**HISTORIC PRESERVATION REVIEW BOARD  
STAFF REPORT AND RECOMMENDATION**

Property Address: **1523 Church Street, NW**  
Landmark/District: **14<sup>th</sup> Street Historic District**

Meeting Date: **January 24, 2019**  
H.P.A. Number: **19-077**

*1523 Church Street, NW (red brick house at center)*

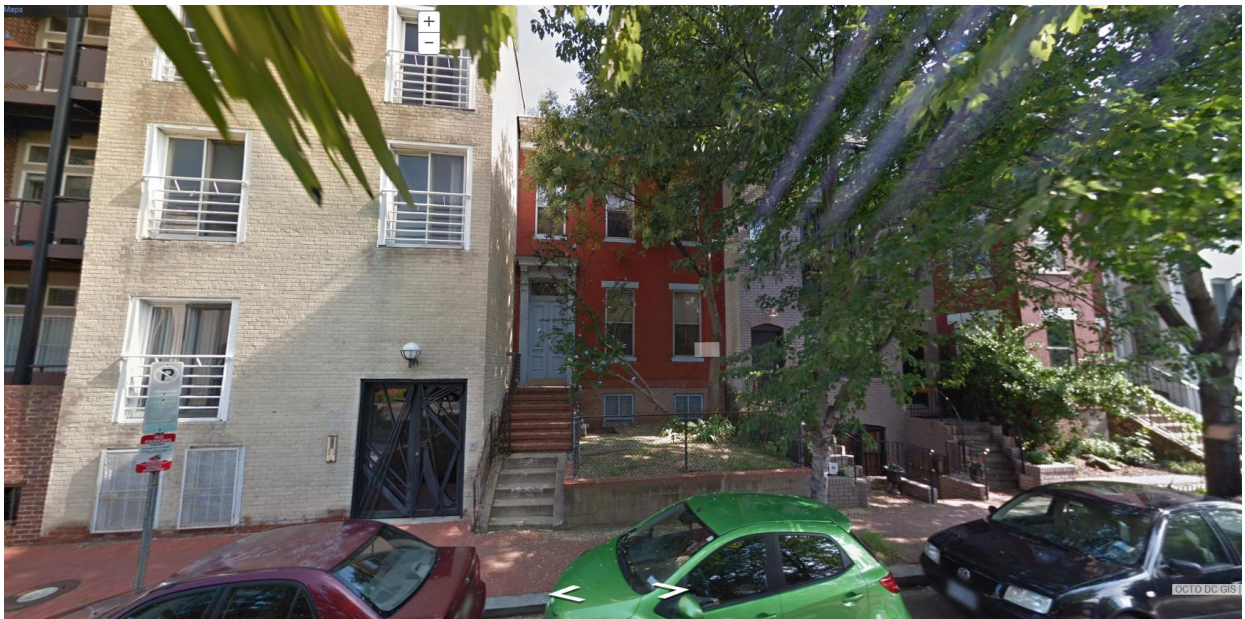
1523 Church Street is a two-story, flat-front brick house set above a partially-raised basement. It was constructed in 1875 and retains its original elevated front yard, although the retaining wall and front stairs to the house are not original.

The house is immediately adjacent to a non-contributing 1950s apartment building to the west that extends out to the edge of the sidewalk and a non-contributing (possibly refaced historic building) to the east. An assortment of contributing rowhouses extends further to the east. A large surface parking lot for St. Luke's Church is located immediately across the street.
